**ENVIRONMENTAL RESTORATION  
RFCA STANDARD OPERATING PROTOCOL  
FOR ROUTINE SOIL REMEDIATION  
FY02 NOTIFICATION #02-09  
IHSS GROUP 900-11  
IHSS 112 – 903 DRUM STORAGE AREA**

**October 2002**

Appendix B Responsiveness Summary

**Figure 5**  
**Native Soil Horizon 1**  
**RFCA Tier I and Tier II**  
**Sum of Ratio Exceedances**

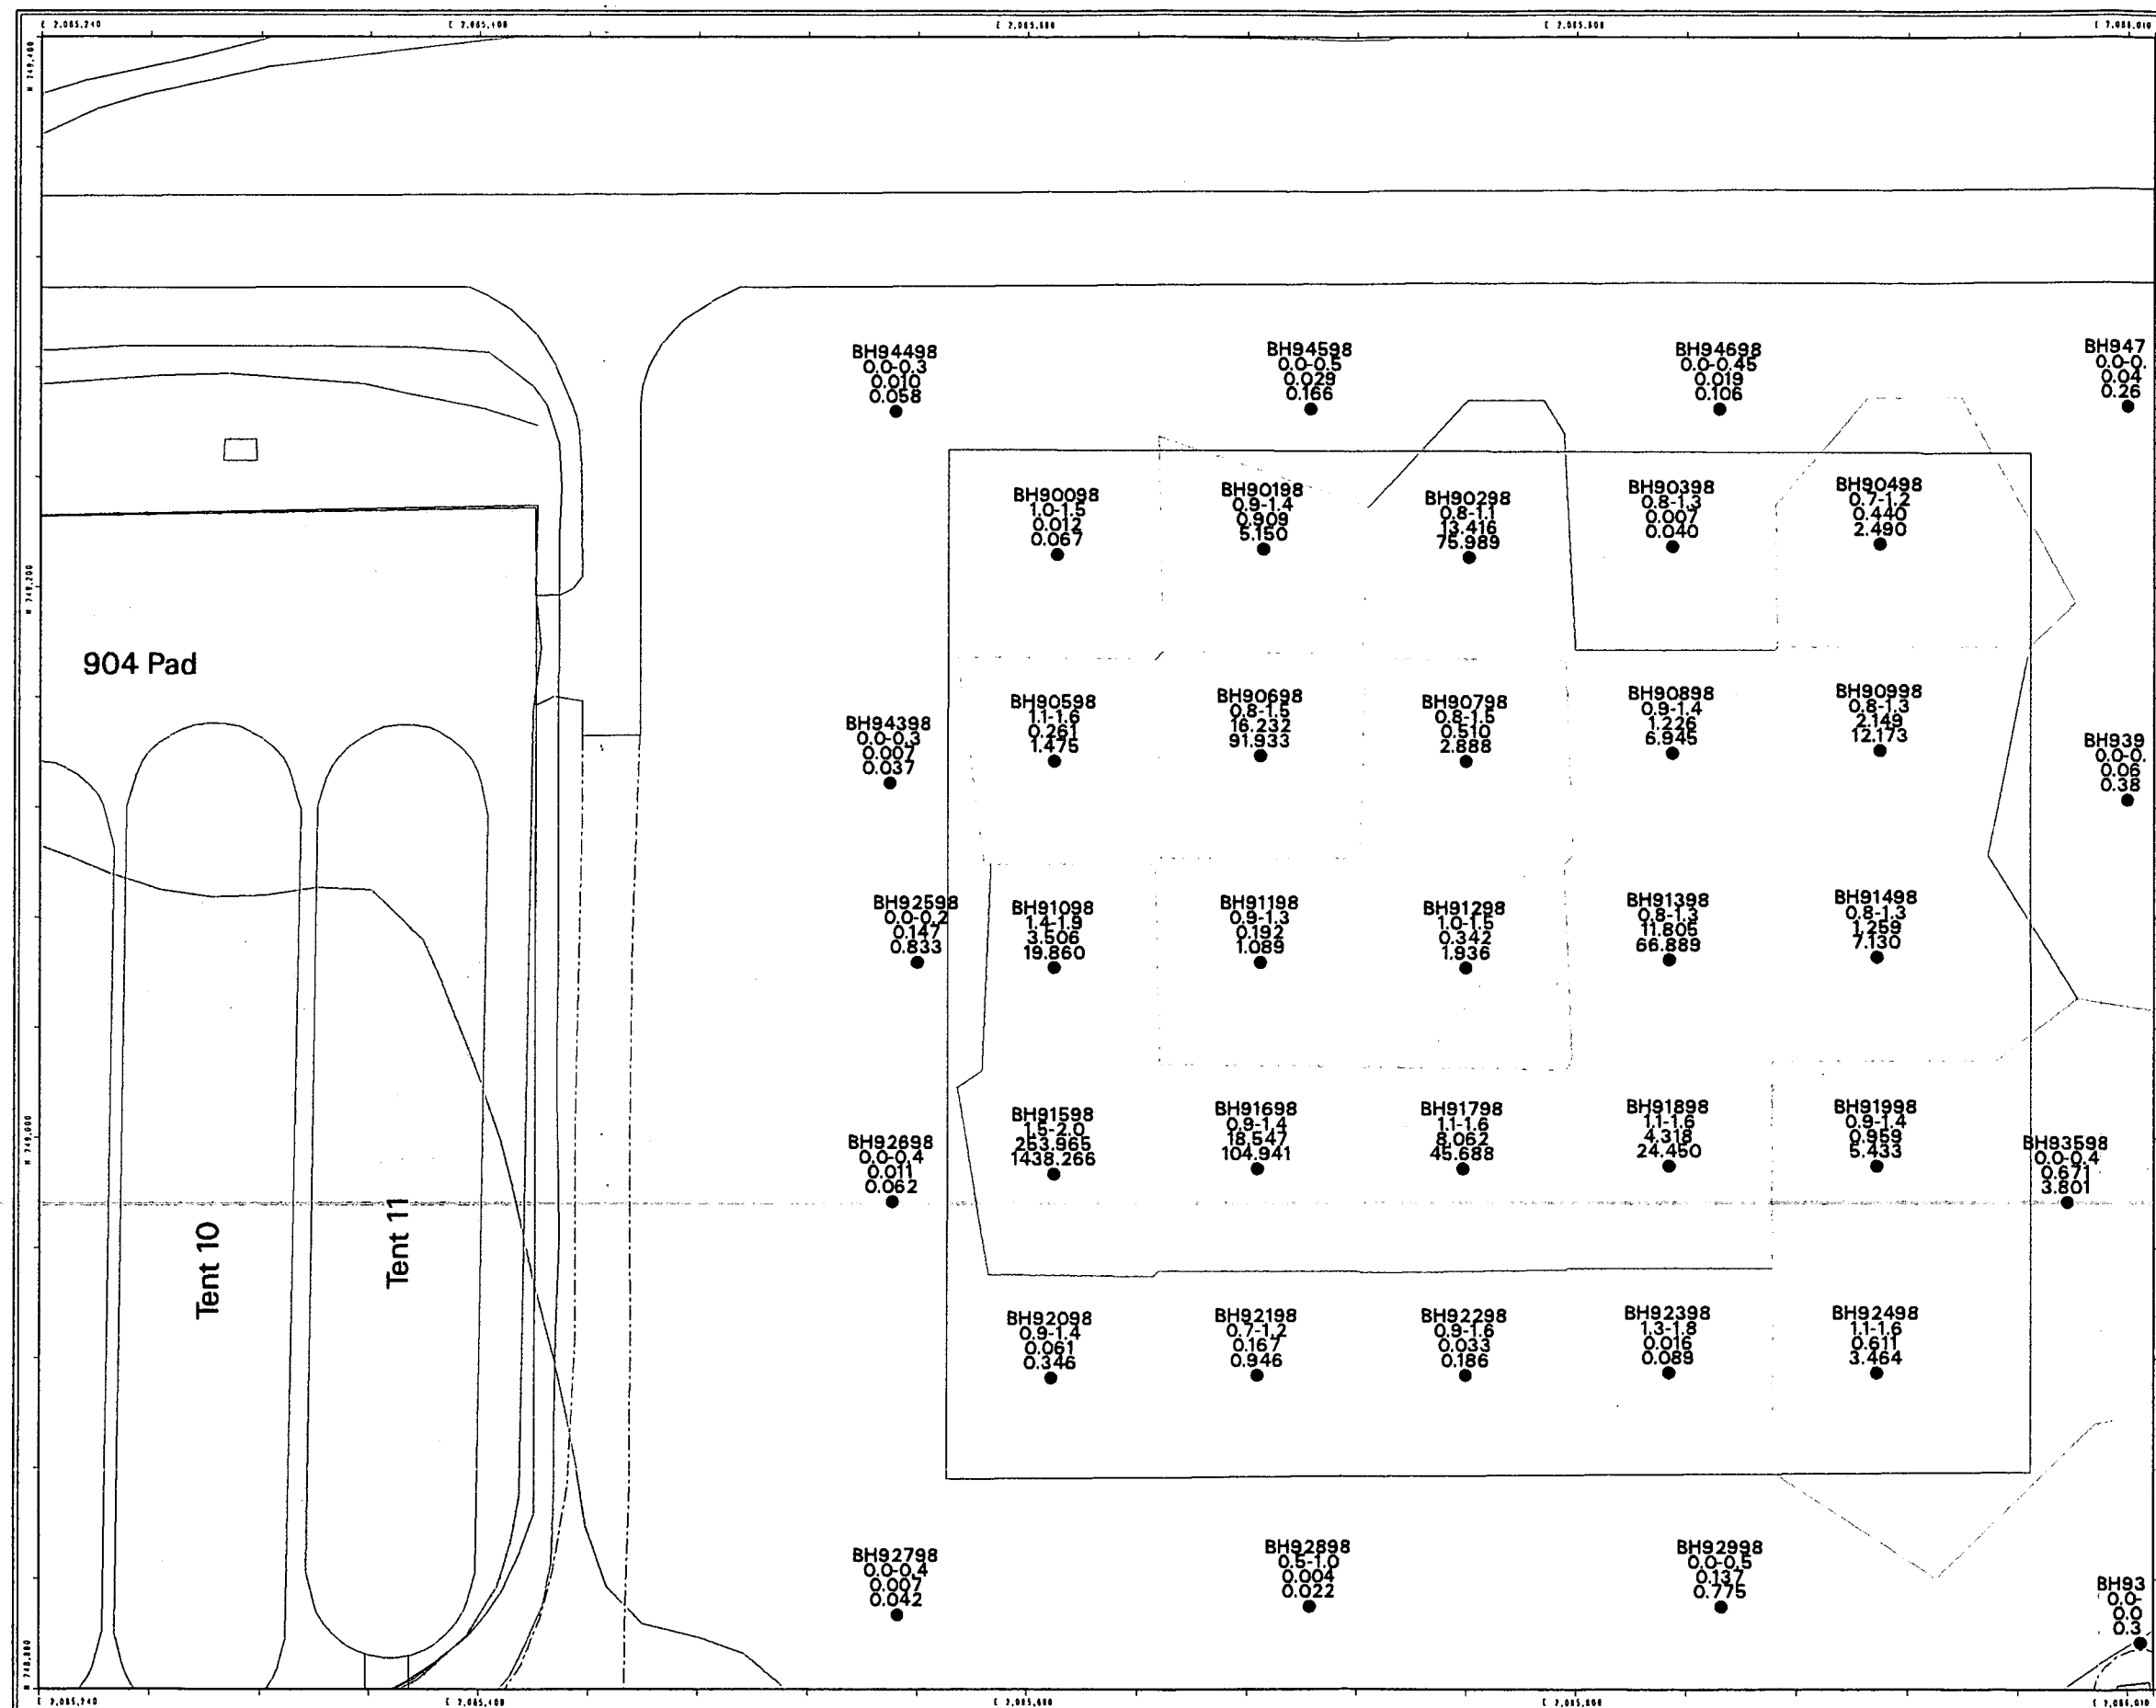
66	<p><b>Figures 5, 6, and 7</b> Additionally, the data shown on these maps and in other tables is compared to 1996 action levels, which will soon be updated with lower calculated values. It would be unwise and misleading to report these values without at least acknowledging that new action levels are pending.</p> <p><i>Response: The data on these maps is compared to current RFCA Tier I and Tier II Action Levels as required by RFCA.</i></p> <p><i>CDPHE Response to Response: By not acknowledging or evaluating the impending implementation of new action levels, K-H/DOE are proceeding at risk.</i></p>	This is understood.
67	<p><b>Section 2.3</b> - When sum-of-ratio calculations are performed on the data in Figures 2, 3, and 4 using the anticipated new calculations, the results are considerably different than in Figures 5, 6, and 7.</p> <p><i>Response: The SOR calculations are based on current RFCA Tier I and Tier II Action Levels as required by RFCA.</i></p> <p><i>CDPHE Response to Response: By not acknowledging or evaluating the impending implementation of new action levels, K-H/DOE are proceeding at risk.</i></p>	This is understood.
